HORSHAM DISTRICT COUNCIL CONSULTATION

TO:	Horsham District Council – Planning Dept
LOCATION:	Old Clayton Boarding Kennels Storrington Road Washington Pulborough
DESCRIPTION:	Approval of details reserved by condition(s) 18, 19, 24 to approved application DC/23/0701.
REFERENCE:	DISC/26/0061
RECONSULT:	1 st set of comments in black 2 nd set of comments in blue
RECOMMENDATION:	More Information / Modification More Information / Modification

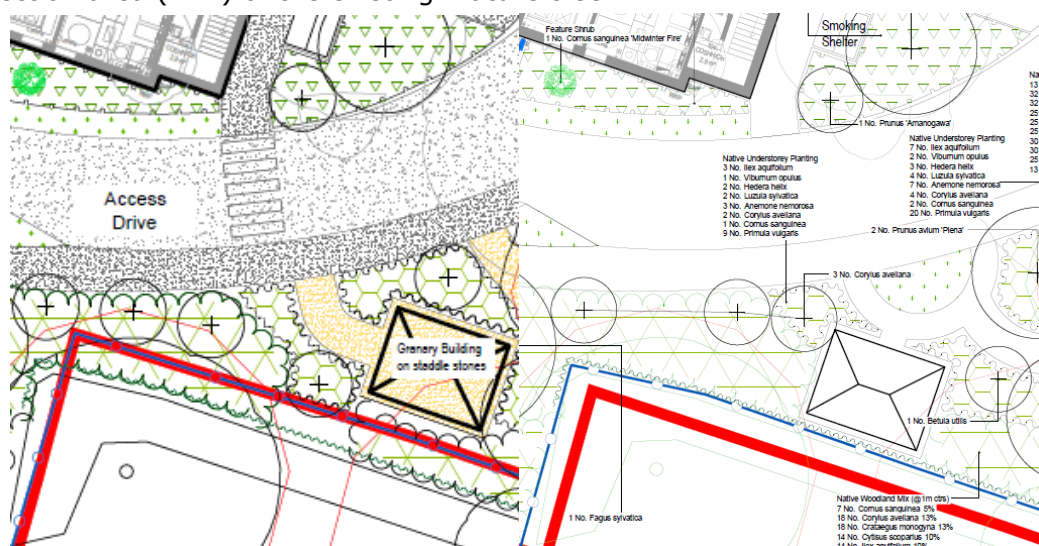
9. We note that the location of the Granary Building [below, left] has been altered from approved layout under DC/23/0701 and DISC/25/0051 [below, right]. Please revert to the originally approved layout in order to prevent unnecessary encroachment of the root protection area (RPA) of the existing mature tree.

We note response dated 31 March 2026 and are satisfied with the justification of the new layout. Closed.
